## STAFF REPORT

<b>File Number</b>	PL 14-156	<b>Contact</b>	Steven Robertson, (218) 730-5295
<b>Application Type</b>	MU-C Plan Review	<b>Planning Commission Date</b>	December 9, 2014
<b>Deadline for Action</b>	<b>Application Date</b>	October 10, 2014	<b>60 Days</b> December 13, 2014 (+30)
	<b>Date Extension Letter Mailed</b>		<b>120 Days</b> February 11, 2014 (+30)
<b>Location of Subject</b>	Corner of East Central Entrance and South Blackman Avenue		
<b>Applicant</b>	Northridge Construction, Inc	<b>Contact</b>	
<b>Agent</b>	Brett Carlson	<b>Contact</b>	bcarlson@northridgenet.com
<b>Legal Description</b>			
<b>Site Visit Date</b>	December 1, 2014	<b>Sign Notice Date</b>	October 28, 2014
<b>Neighbor Letter Date</b>	October 27, 2014	<b>Number of Letters Sent</b>	29

The applicant is proposing to build a 4 story and 98 room hotel. Any new structures in the MU-C district over 500 square feet need a plan review at a public hearing by the Planning Commission.

#### SITE PLAN

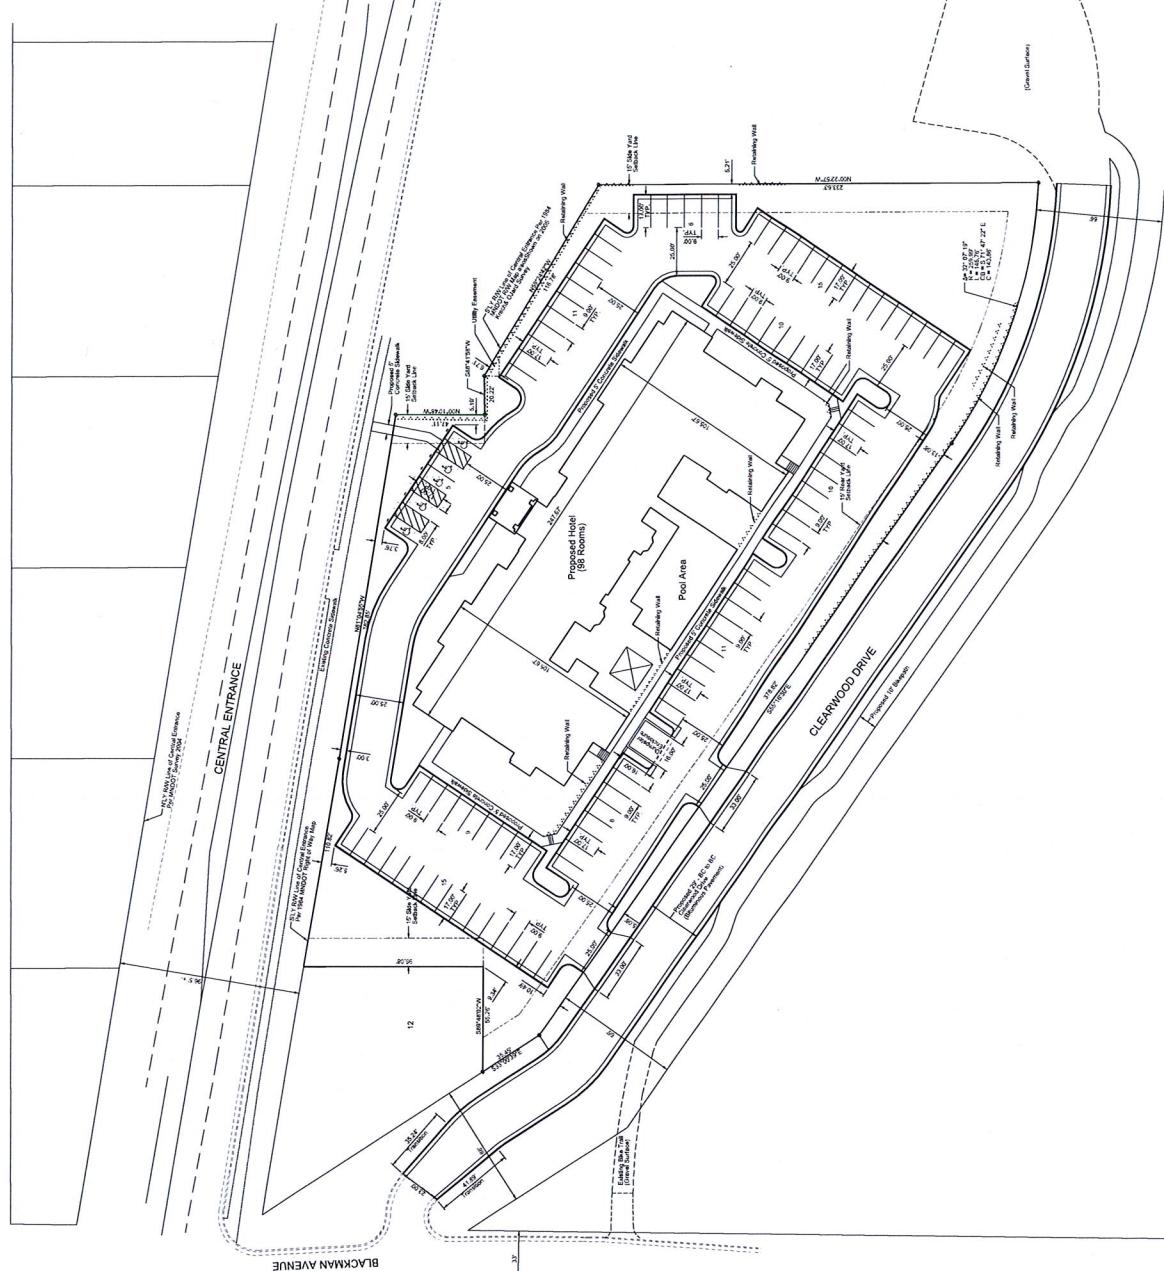
- 4) 50-24 (Parking and Loading). Project provides 100 parking spaces; no more than 50% of parking will be in front of the structure.
- 5) 50-25 (Landscaping and Tree Preservation). Applicant has completed the tree preservation plan, and it has been reviewed by the City Forester. The landscaping plan is currently being revised (at the time this staff report was written) to show compliance with the 15% interior lot landscaping, 30% tree canopy coverage, and street frontage landscaping.

- 8) 50-30 (Building Design Standards). Applicant will submit revised information on how they are complying with this requirement.
- 9) 50-31 (Exterior Lighting). The lighting plan substantially complies with the limit at the property line, but exceeds the maximum illumination at a few areas around the property line. The applicant will need to submit additional information on the type of light fixture and light pole that will be used; this can be submitted with the building permit application.

- 1) The project be limited to, constructed, and maintained according to site plans dated 11/21/14
- 2) Applicant revise lighting plan to show compliance with UDC section 50-31, Exterior Lighting, and revise landscape plan to show compliance with UDC section 50-25, Landscaping and Tree Preservation
- 3) Any alterations to the approved plans that do not alter major elements of the plan may be approved by the Land Use Supervisor without further Planning Commission; however, no such administrative approval shall constitute a variance from the provisions of Chapter 50.
